# UNITED STATES PATENT AND TRADEMARK OFFICE

APPLICATION NO.	FILING DATE	FIRST NAMED INVENTOR	ATTORNEY DOCKET NO.	CONFIRMATION NO.
09/872,704	06/01/2001	Randy L. Morningstar	687-442	2503
40636	7590	06/26/2006		
AMS RESEARCH CORPORATION 10700 BREN ROAD WEST MINNETONKA, MN 55343			EXAMINER MITCHELL, TEENA KAY	
			ART UNIT	PAPER NUMBER
			3743

<b>Office Action Summary</b>	<b>Application No.</b>	<b>Applicant(s)</b>	
	09/872,704	MORNINGSTAR, RANDY L.	
	<b>Examiner</b>	<b>Art Unit</b>	
	Teena Mitchell	3743

## **DETAILED ACTION**

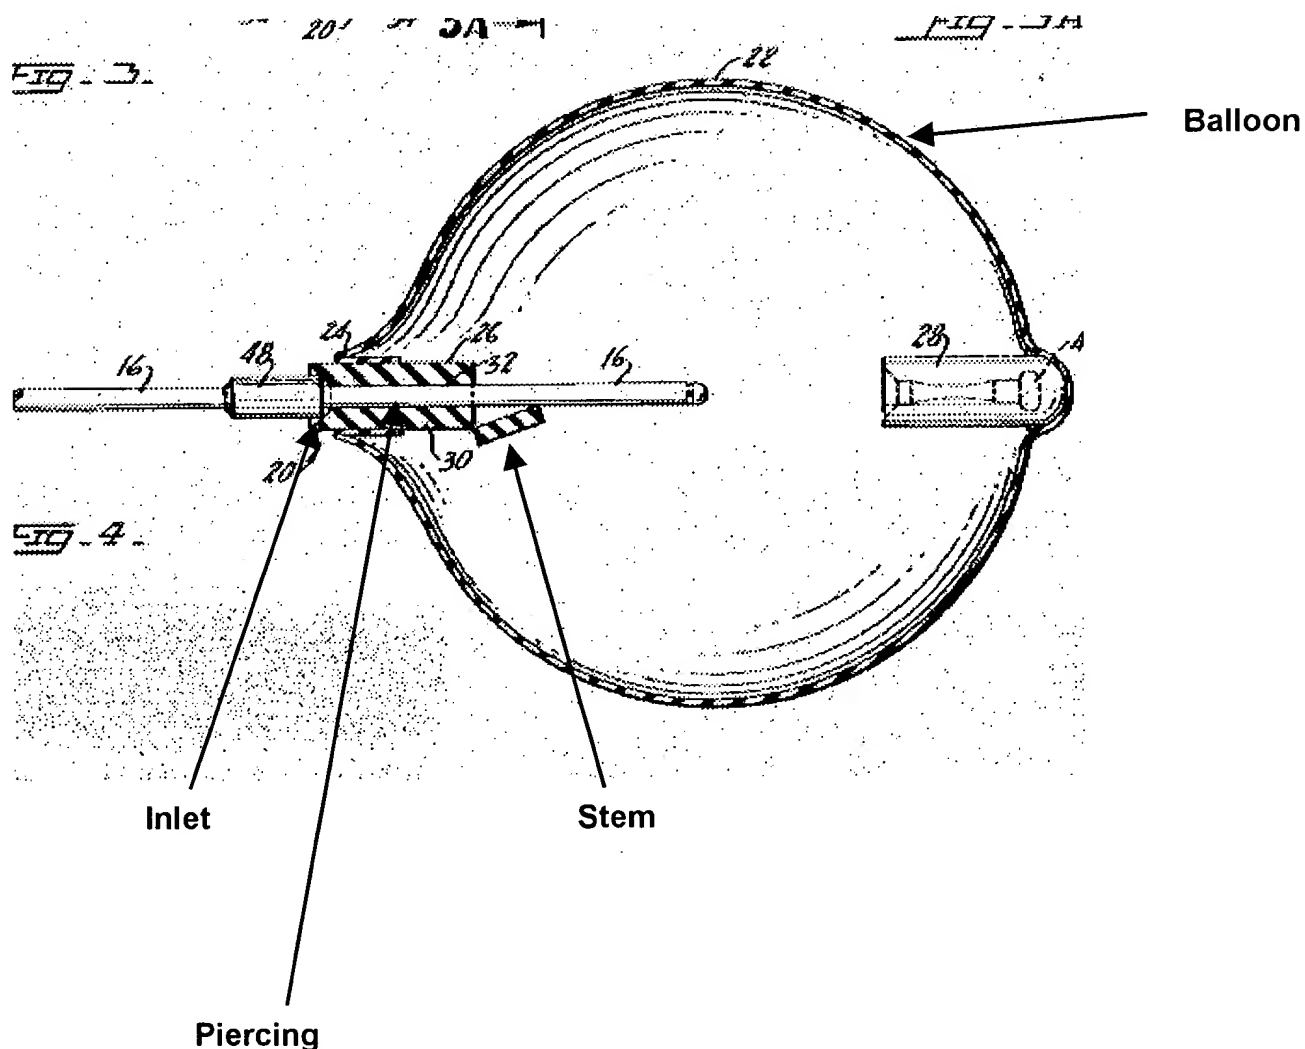
**Claims 1, 2, 4-8, and 10 are rejected under 35 U.S.C. 102(b) as being anticipated by Pecenka (4,517,979).**

Pecenka in an implantable balloon discloses (SUMMARY OF THE INVENTION):  
a valve portion (at 20) having: a valve body (at 26) defining an inlet; a valve inlet stem (see illustration of Fig. 4 below) extending from said inlet, through said body opposite said inlet; a piercing (see illustration of Fig. 4 below) extending from said inlet, through said body and stem, said valve portion constructed from a soft, elastomeric material having memory thereby causing said piercing to remain closed and fluid-tight unless penetrated by a relatively rigid member (e.g. 16); a balloon portion (22), integral with said valve portion, constructed and arranged to receive and hold fluids exiting said piercing opposite said inlet.

With respect to claim 2, Pecenka discloses wherein said valve stem comprises at least one side (note illustration of Fig. 4 above).
